RE: Coal Valley Resources Inc. Robb Trend Project, Environmental Impact Assessment and Mine Permit Application under the *Coal Conservation Act* (“CCA”) and Environmental Protection & Enhancement Act (EPEA), ERCB Application 1725257, EPEA -028-00011066, Supplemental Information Request Round 2

On March 26, 2013 CVRI received the final combined version of the second round of SIR's from ESRD, ERCB and CEAA. CVRI has prepared the attached document that fully addresses all issues and questions raised in this second round of SIR's. CVRI believes that all matters with respect to the completion of the environmental assessment review processes have been completed and that the Project authorizations could now proceed.

DRAWING NO.
Fig 3-10

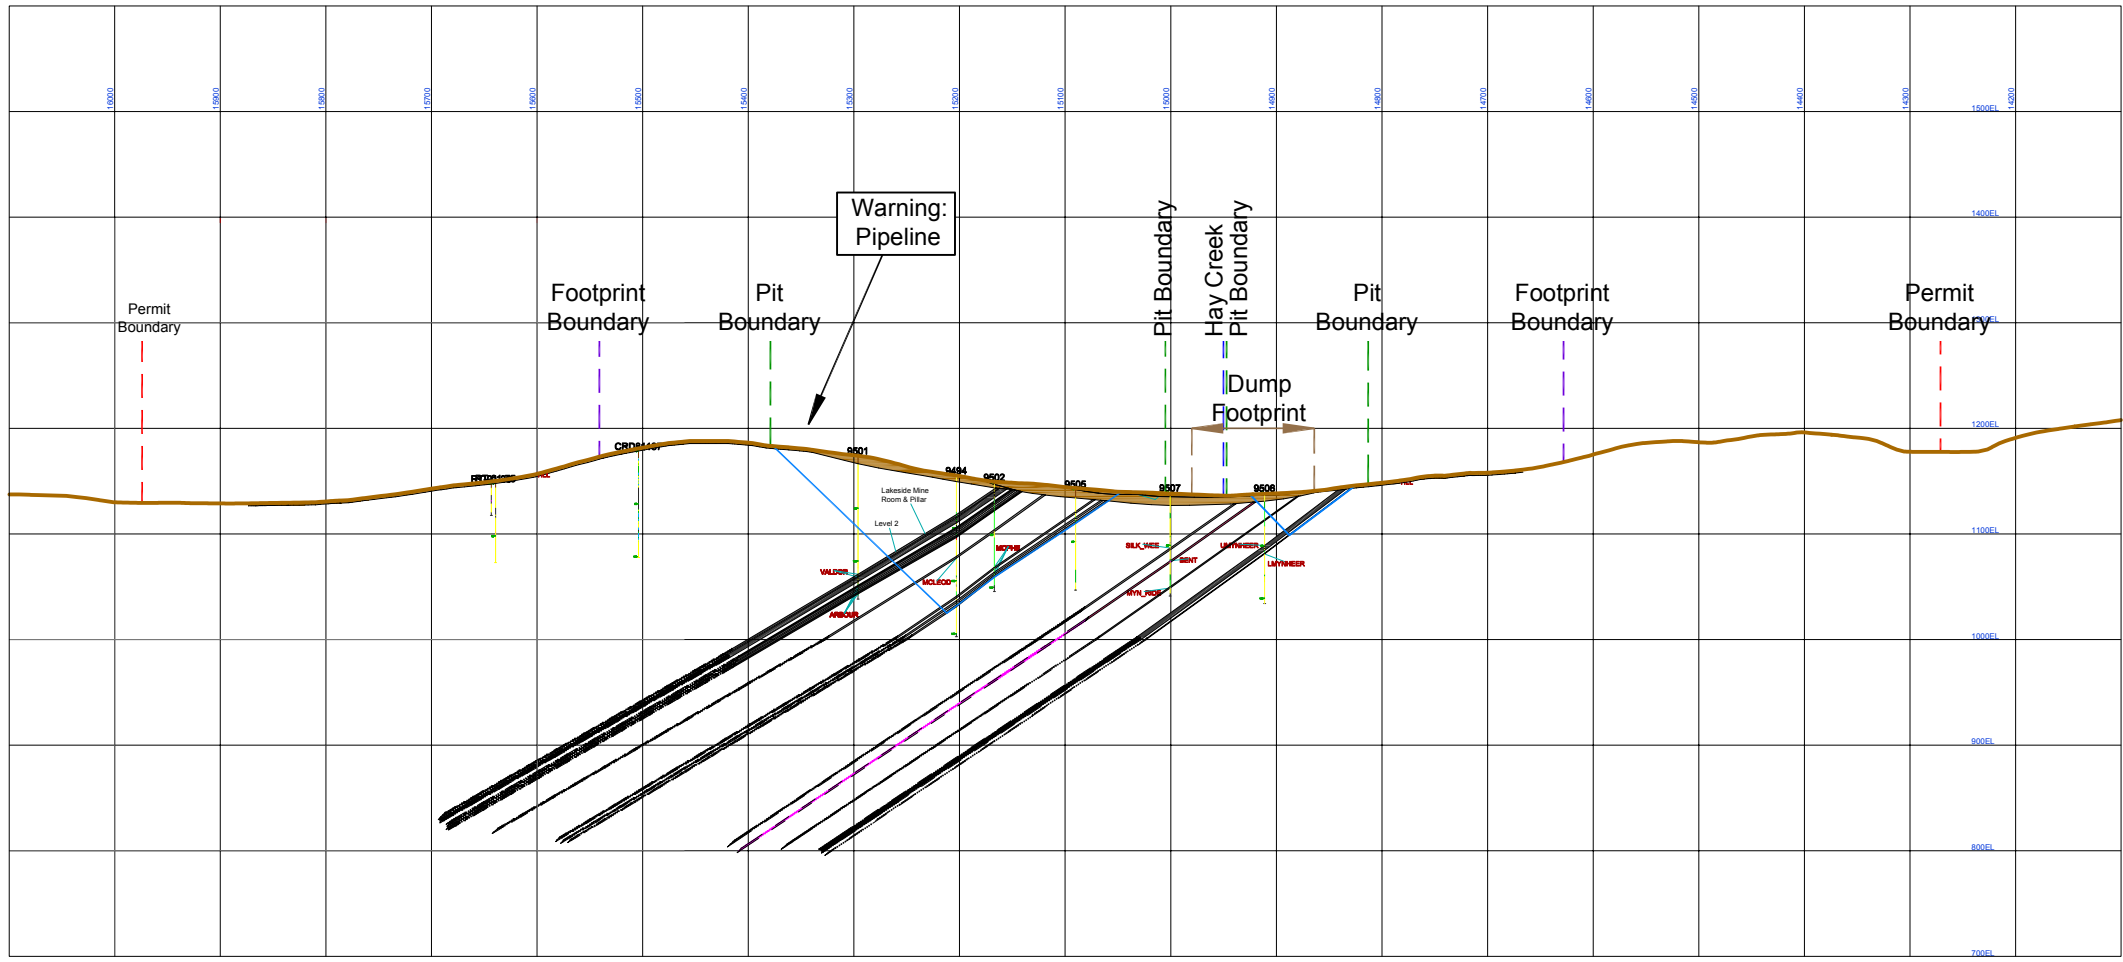
CVRI has provided modified cross sections as requested (see [ERCB SIR2 #3a](#)). The locations of underground workings have been added to four of these sections. [ERCB SIR2 Figure 3-10](#) (5900E) illustrates the location of the eastern extreme of the Lakeside Mine. [ERCB SIR2 Figure 3-6](#) (1900E), [ERCB SIR2 Figure 3-4](#) (1500E) and [ERCB SIR2 Figure 3-2](#) (700E) illustrate intersections with underground workings associated with Bryan Mine. As noted previously the proposed mining will encompass the whole of the old workings within these sections. This factor was noted to indicate that the workings would not form part of the highwall. Of course, the workings would intersect with the 'end walls'.
